SUNDALE DEVELOPMENTS

12-16 BENT STREET - LINDFIELD

LANDSCAPE RESPONSE TO SDRP REVIEW 2 (2 APRIL 25)

S24-01924 • 25/09/2025

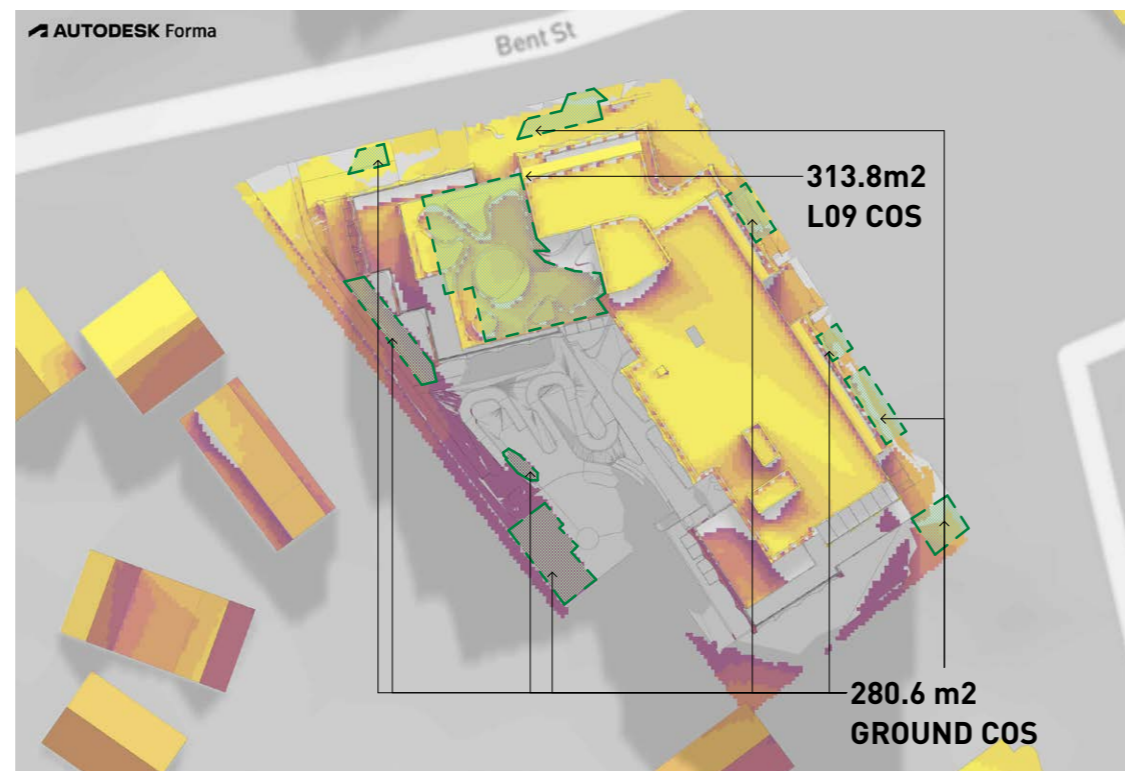
- Recalculate the area of the COS considering the useable and functional parts, as recommended by the ADG. Walkways and buffer zones with landscaping should not be included in the calculation of the principal COS area.

- The principal Communal Open Space area has been recalculated to exclude walkways and buffer zones with landscaping. To satisfy the 25% ADG requirement, additional communal open spaces have been added at the southwest walkway area and along the internal walkway at the Drovers Way interface.

COS Solar Analysis 21 June 9AM to 3PM

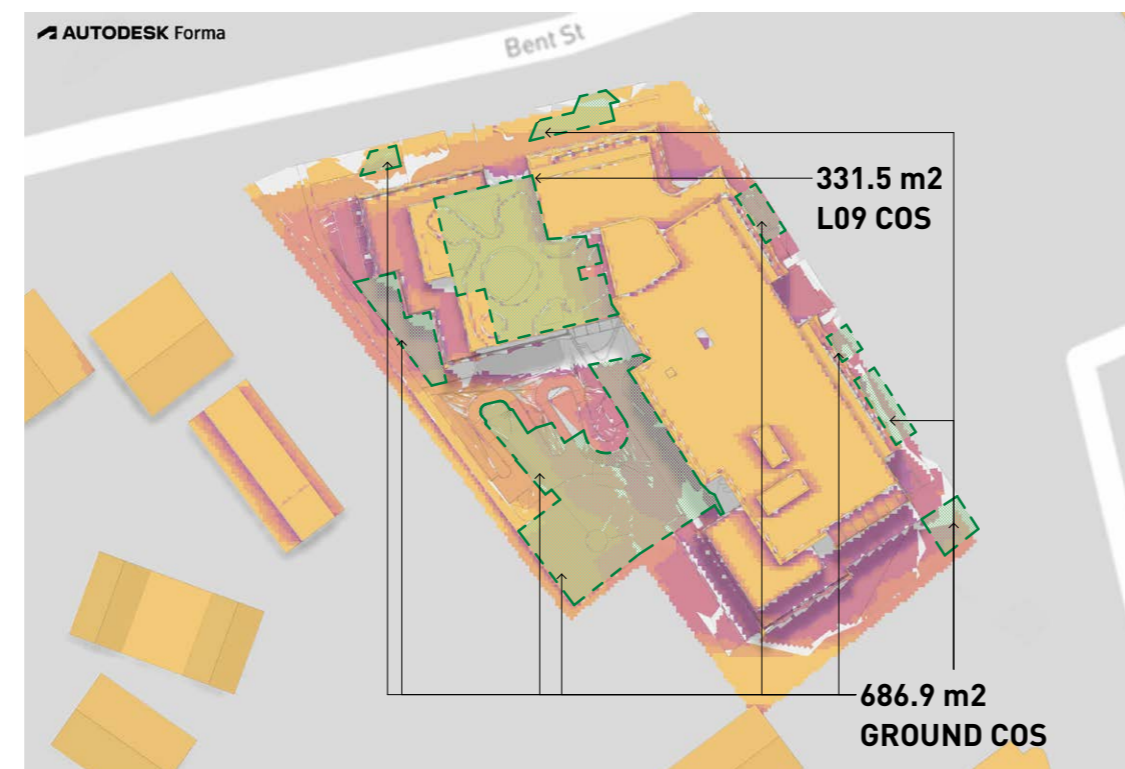
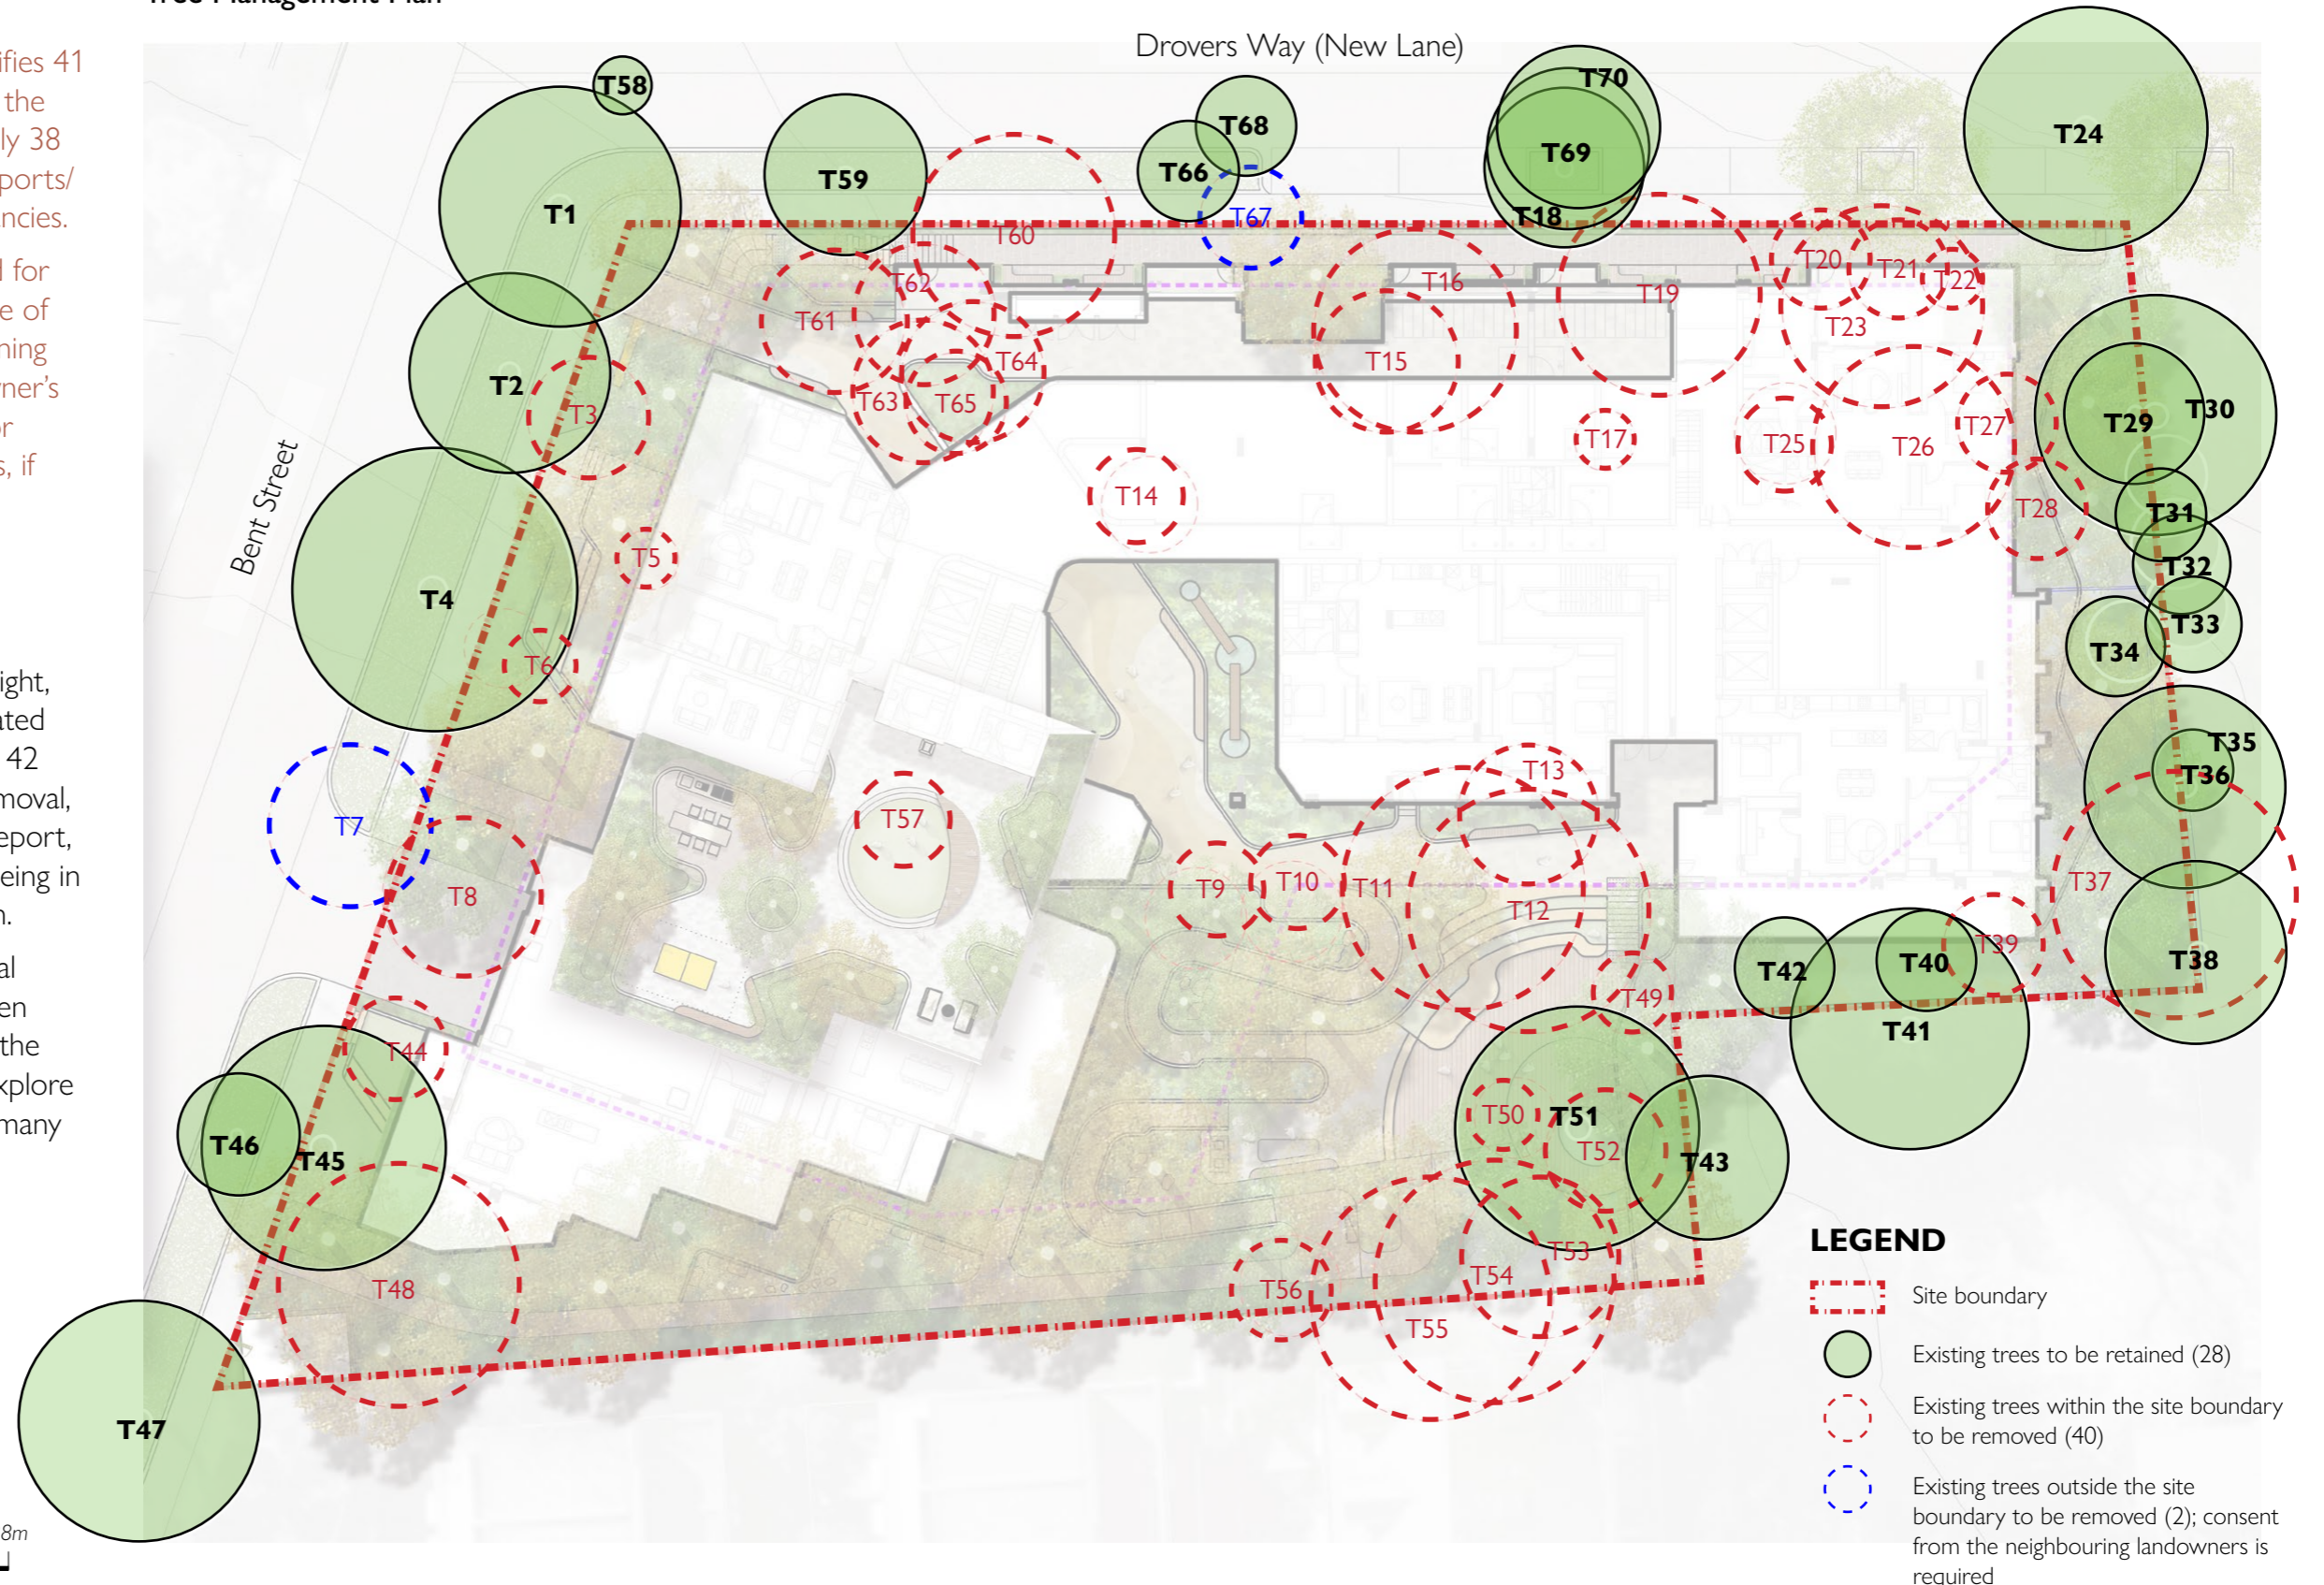
- Demonstrate what percentage of the proposed rooftop COS area receives two hours of solar access between 9am – 3pm mid-winter, having regard to the ADG design criteria.

- The Level 9 COS will receive in excess of 2 hours sunlight during mid-winter, refer to updated solar access diagrams on the right as extracted from the architectural drawings.

Tree Management Plan

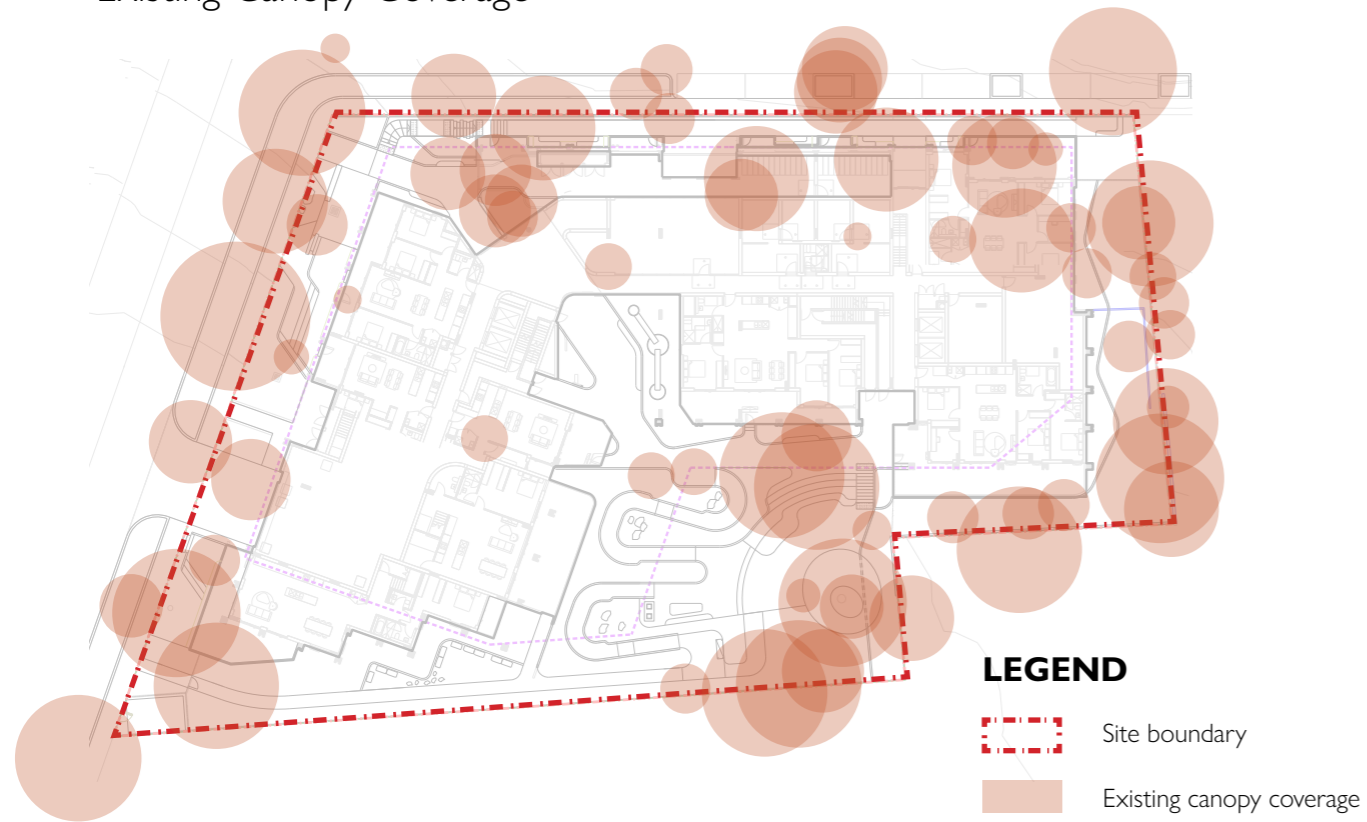
- The Arborist Report identifies 41 trees for removal whereas the landscape plans identify only 38 trees. Please amend the reports/plans to avoid any discrepancies.
- Two of the trees proposed for removal are located outside of the site boundary on adjoining land. Neighbouring landowner's consent will be required for removal of these two trees, if proposed.

- Refer to the updated Tree Management Plan on the right, it now aligns with the updated Arborist Report, a total of 42 Trees are proposed for removal, as noted in the Arborist Report, and all were identified as being in low or moderate condition.
- It is noted that the Proposal was developed and has been maintained in response to the SDRP panel's request to explore opportunities to retain as many existing trees as possible.

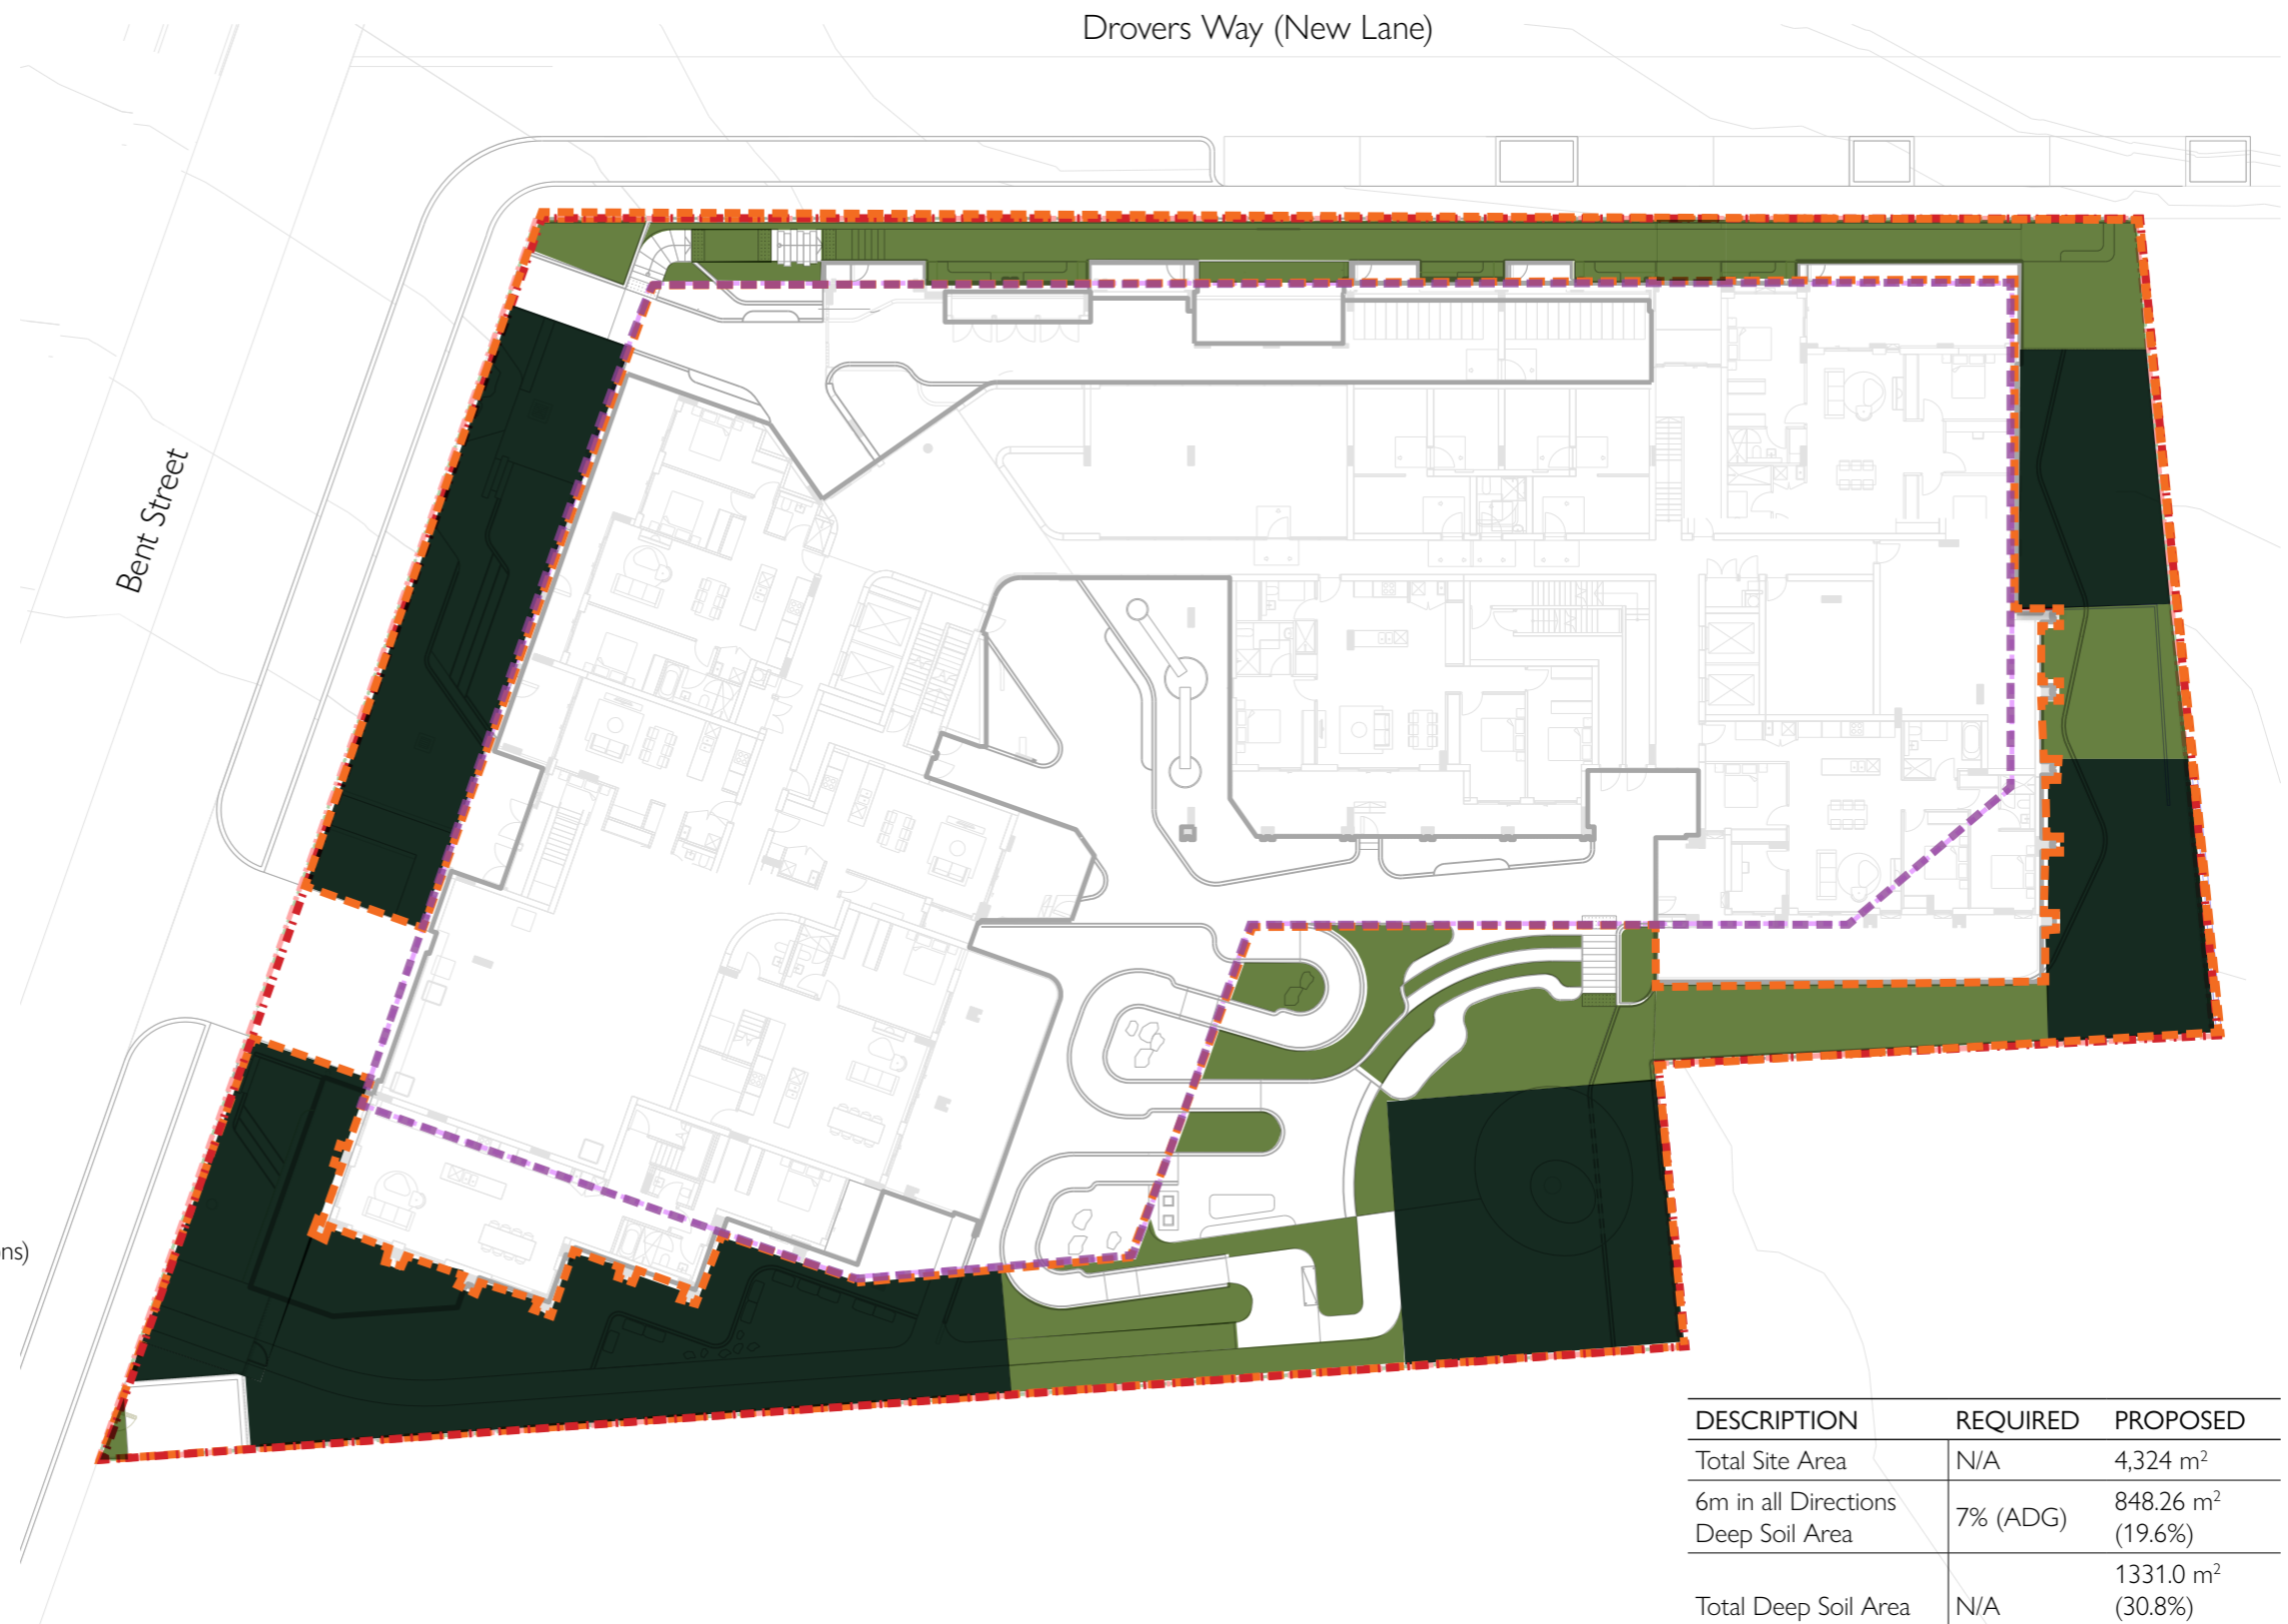
- The retaining wall for the overland flow path appears to be located in the outdoor Amphitheatre area. Please clarify how both elements are intended to be designed and integrated within the same space.
- Confirm whether the materials proposed for the Amphitheatre will be waterproof and consider using materials that can withstand the overland flow through this area.

- Refer to Stormwater Engineer's report for details on the materials specified for use within the floodway.
- Refer to Section BB and the 3D modelling image on page 18, which illustrate the relationship between the suspended decking and the retaining wall for the overland flow path.
- Refer to Stormwater Engineers' report for information demonstrating that the proposed materials are suitable for their intended use adjacent to the overland flow path.
